Notice of Allowability

10/813,610

WAKABAYASHI ET AL.

Fig. 11

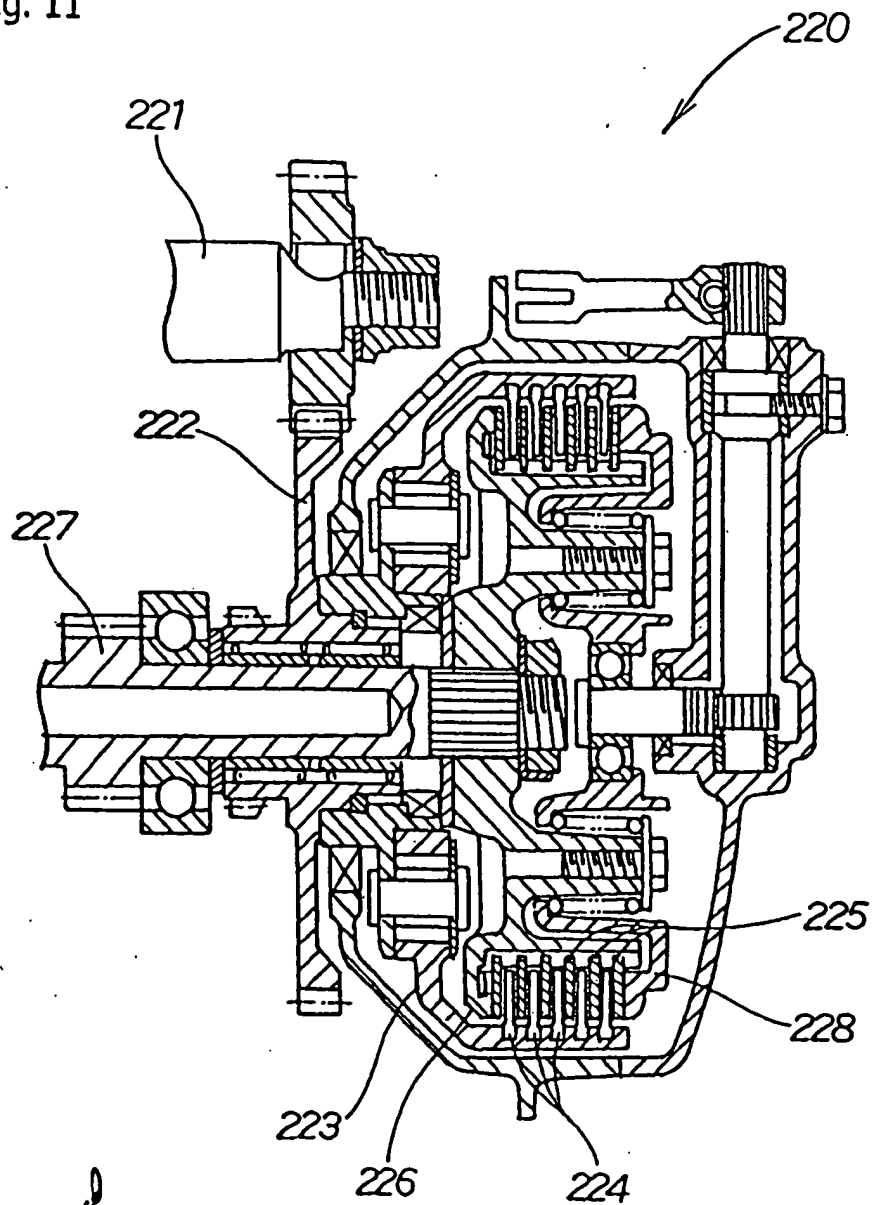
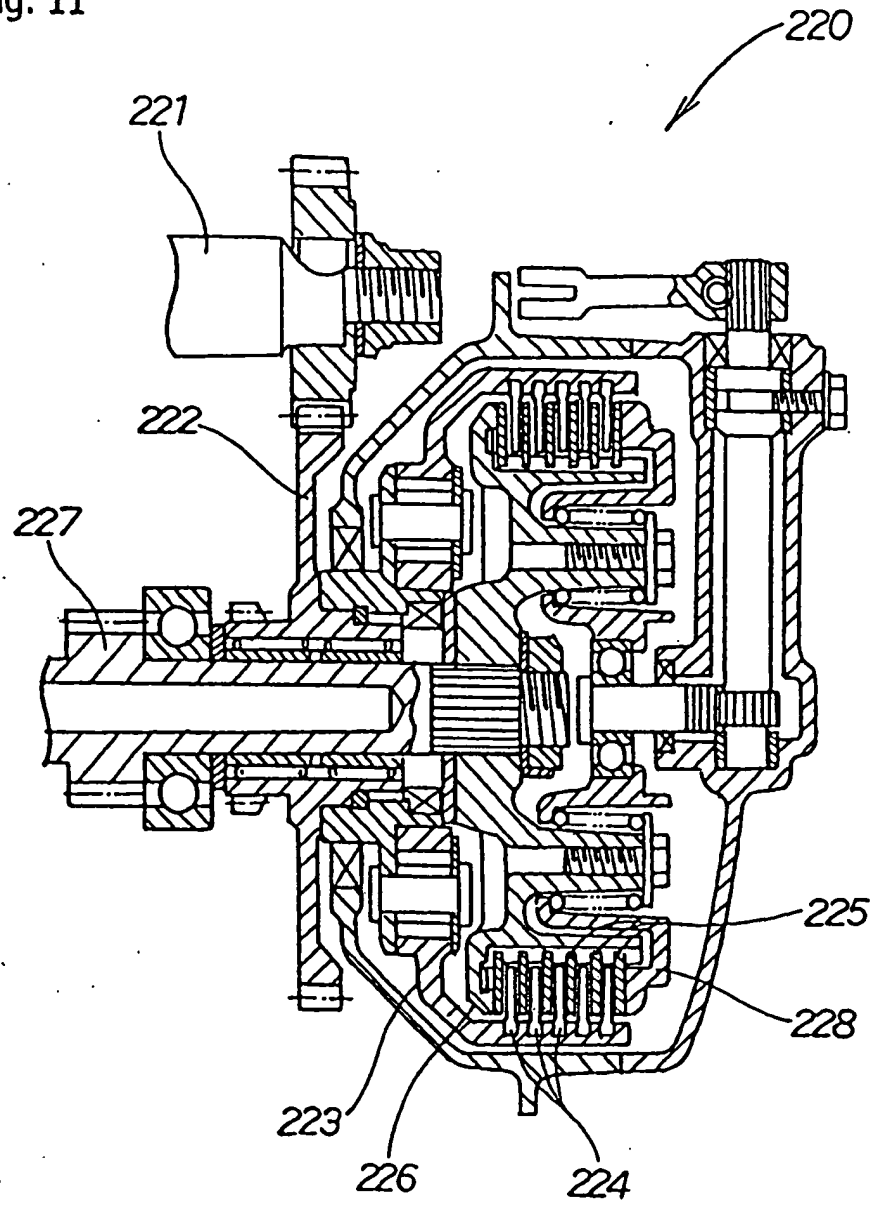
Previously omitted label is added.
